City of Portland, Maine – Building or Use Permit Application 389 Congress Street, 04101, Tel: (207) 874-8703, FAX: 874-8716

BUILDING PERMIT REPORT

REASON FOR PERMIT: Porch - door - bulkhead enclosure.

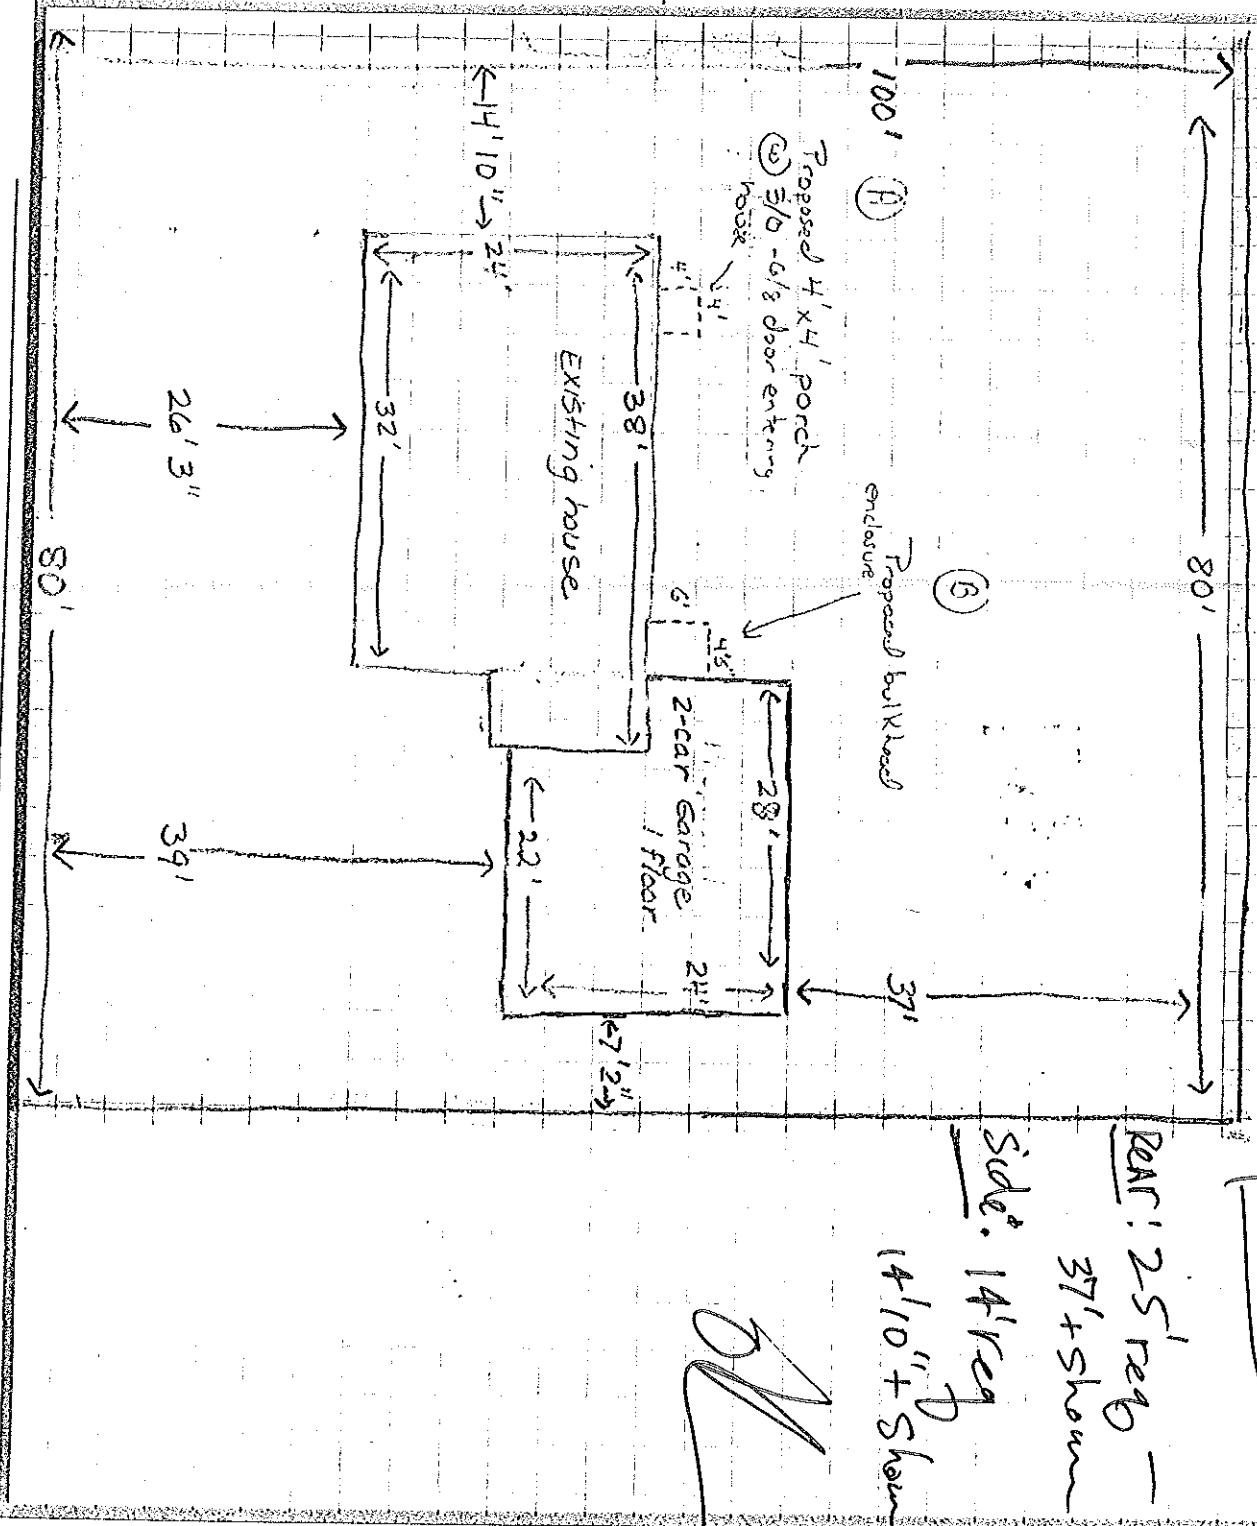
Side: 14' req
 14' 10" + Show
 Rear: 25' req -
 37' + Show

STAIR CONST
SEC. 1014.0

Guardrail 1022.0
Handrail 1021.0
FOOTINGS
